Invitation for Bid: MEADE COUNTY ROAD DEPARTMENT BUILDING
BID NO: 2026-01

ADDENDUM #2 RESPONSES TO QUESTIONS:

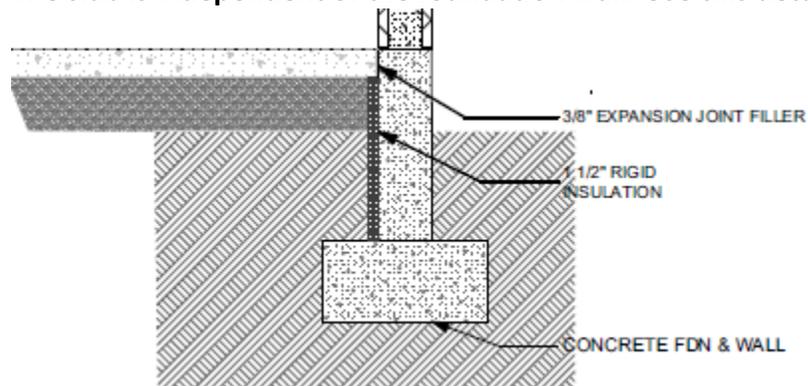
1. Is there WWM reinforcing steel in the building slab or rebar?
 - a. **Use 6x6 w2.9/2.9 in the slab (single row)**
2. Does the slab get tied into the foundation wall with steel and if so, what size and spacing?
 - a. **The slab is independent of the foundation wall. Use this detail as an example.**
